TYPE 1203-B UNIT POWER SUPPLY

The popular, general-purpose Unit Power Supply TYPE 1203-A, designed primarily to provide a-c heater and d-c plate power for General Radio Unit Instruments, has been replaced by an improved version TYPE 1203-B. The circuit of the new model has been revised to include additional filter capacitance, thereby reducing the output ripple. By a rearrangement of components, the fuses have been moved to the front panel for greater convenience of servicing.

View of the Type 1203-B Unit Power Supply.

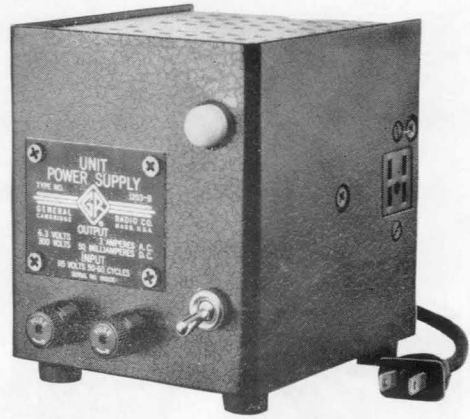
The 230 v, 50-cycle model TYPE 1203-AQ11 has been replaced by the TYPE 1203-BQ18 for 230 v, 50- to 60-cycle service.
